STORMWATER SITE PLAN

Proposed Wesley Homes Puyallup Senior Living Project Phase II

Northwest Corner of 10th Street S.E.
and 39th Avenue S.E.
Puyallup, Washington

July 6, 2023
Our Job No. 16718

Minimum Requirement No. 3: Source Control of Pollution.

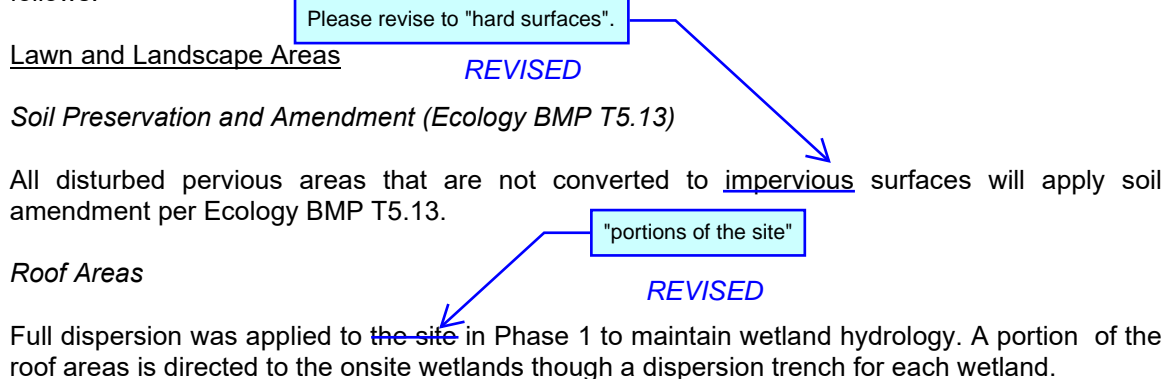
Address BMP T7.30 and BMP T5.10B also.
[Storm Report; Pg 5 of 503]

Verify.
[Storm Report; Pg 5 of 503]

REVISED TO "NOT PROPOSED"
